Final After Action Report For North Lobe Dredging

New Bedford Harbor Superfund Site Operable Unit No. 1 New Bedford, MA

North Lobe Dredging After Action Report Consolidated Response to Comments

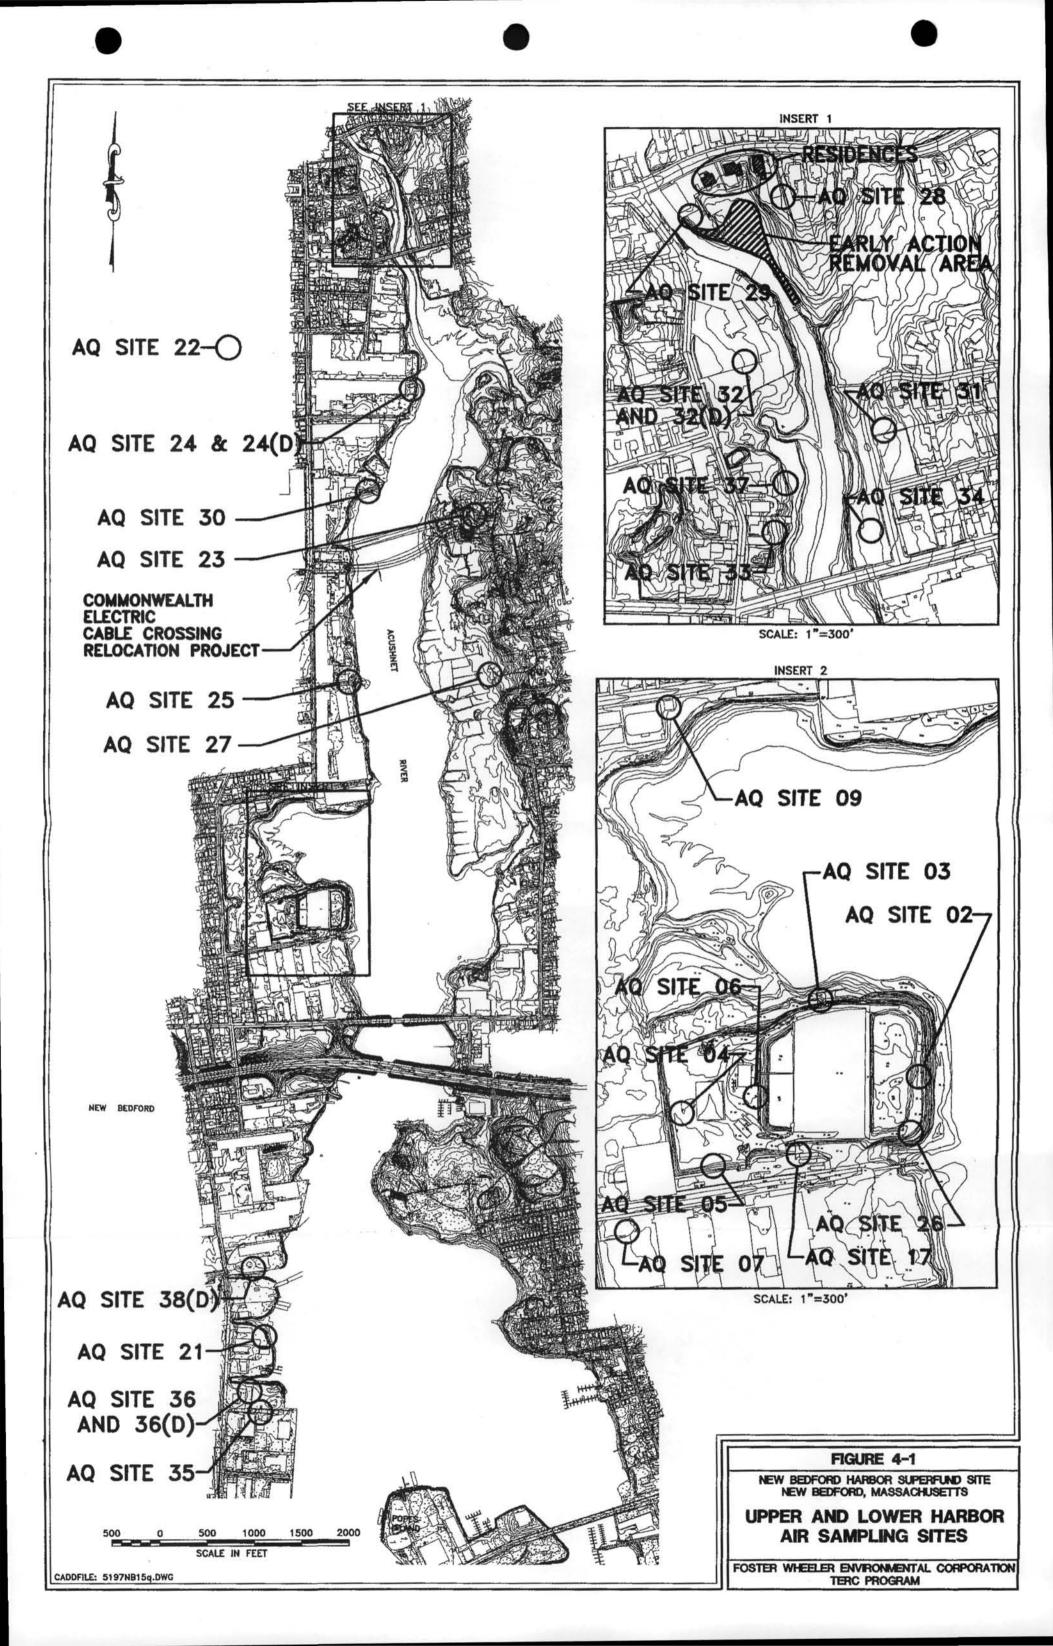
- * Disagree. Transmittal numbers have not been included.
 - Transmittal numbers have been included.
- Page 4-4, section 4.9.1, 1st sent.: Figure 4-1 is not included.

- o Figure 4-1 is included in the updated draft report.
 - * Accepted.
- Page 4-4, Section 4.9.1, 2nd para.: Delete the first sentence.
 - o Sentence was deleted.

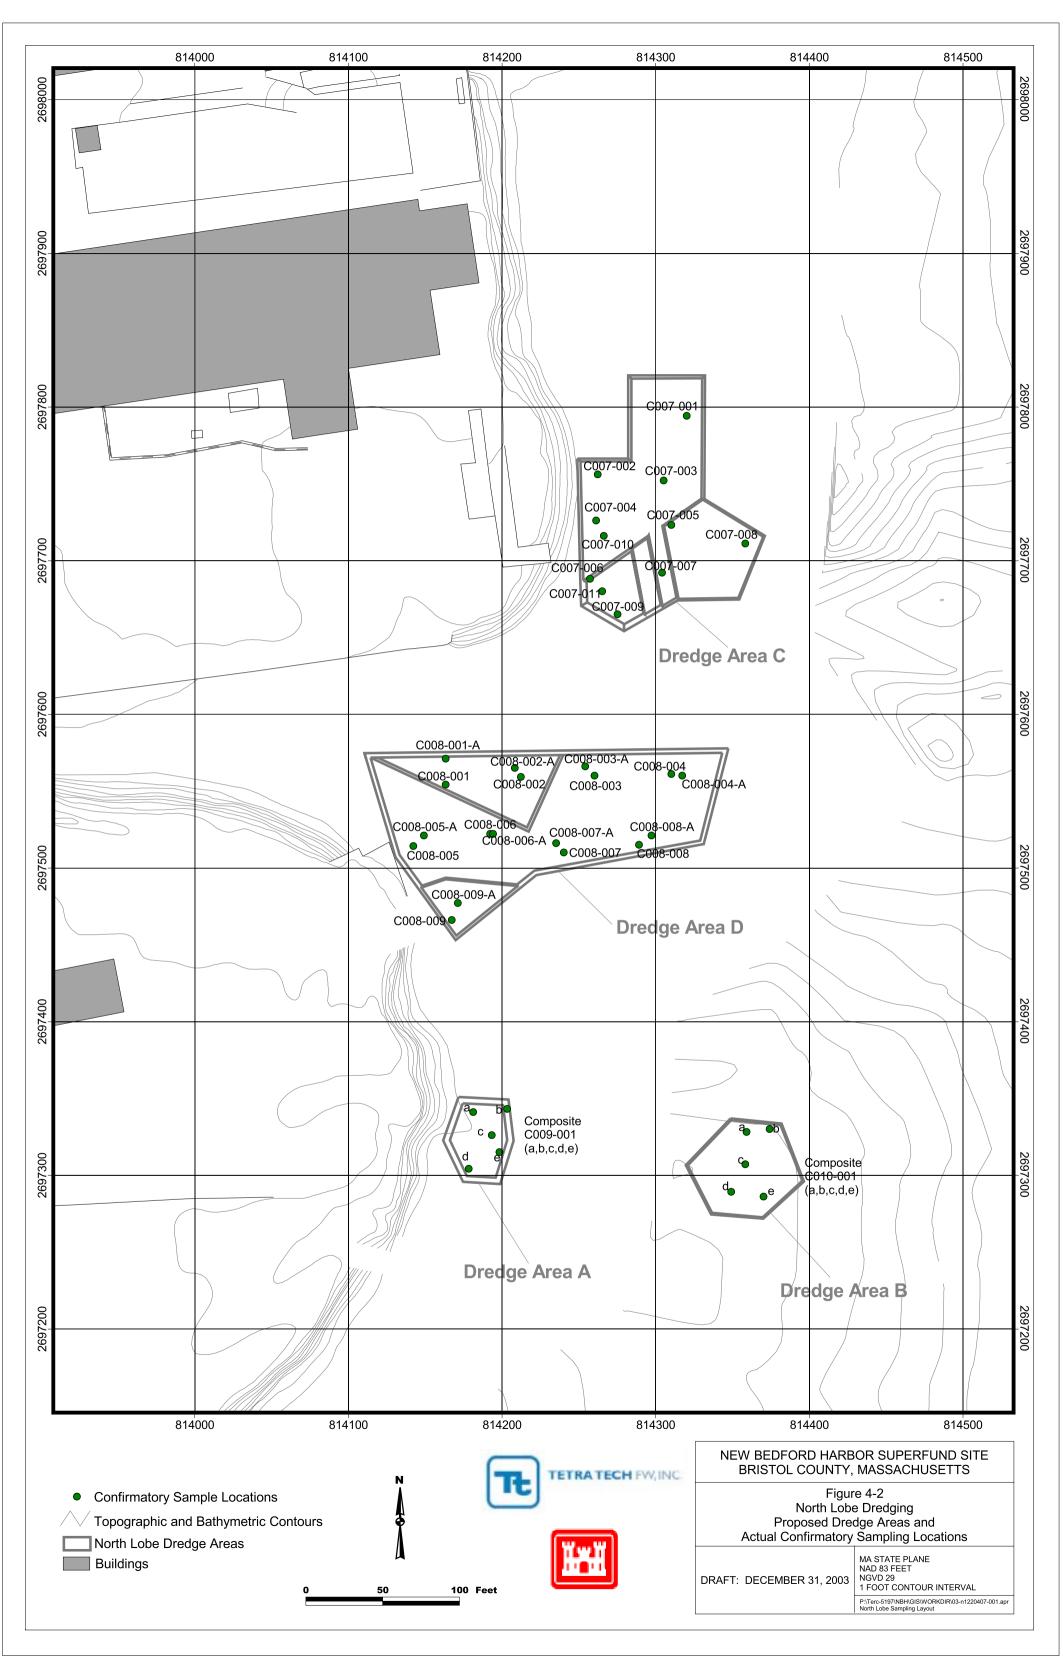
- Page 4-6, Section 4.9.2: In the title, change "Confirmation" to "Confirmatory".
 - o Changes made as indicated.
 - * Accepted.
- Page 4-6, Section 4.9.2, 2nd sent.: Figure 4-2 is not included.

- o Figure 4-2 was included in the updated draft report.
 - * Accepted.

Appendix B
Figure B-1 North Lobe Dredging Proposed Dredge Areas and
Actual Confirmatory Sampling Locations

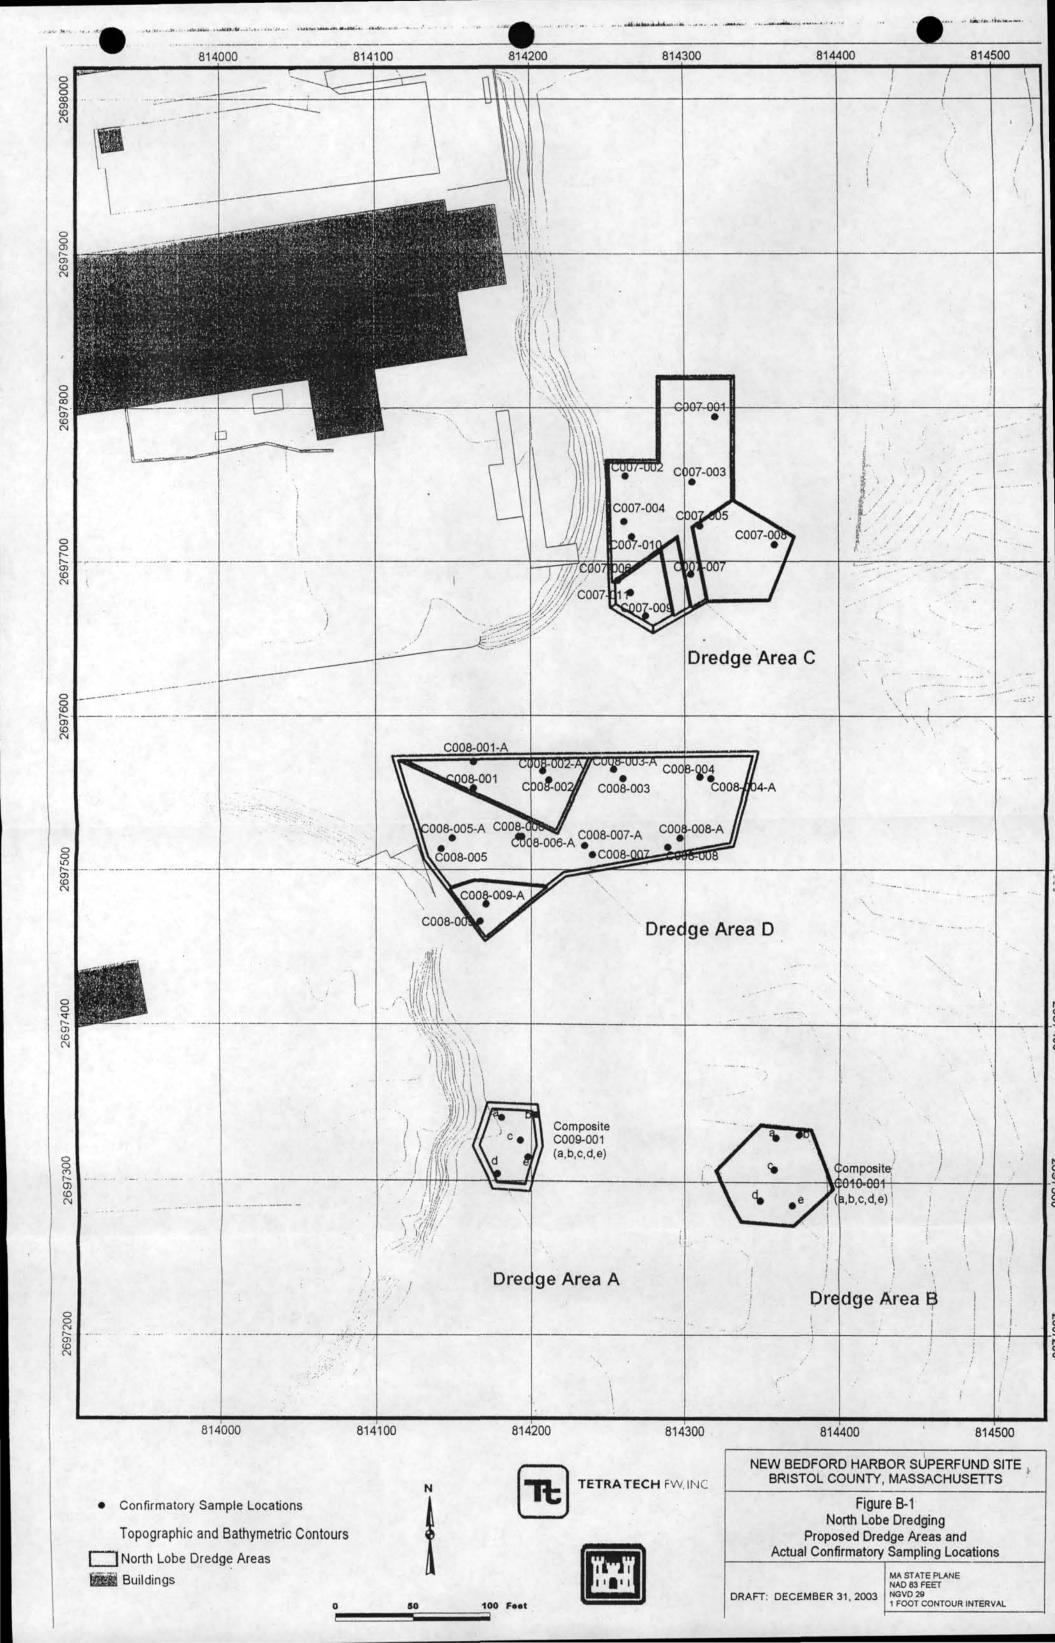
- * Include a signed copy of the Eng. Form 4025 indicating that the Report has been approved. Figure B-1 of the Report is illegible and should be replaced.

- The signed Eng. Form 4025 has been included as well as a legible copy of Figure B-1.
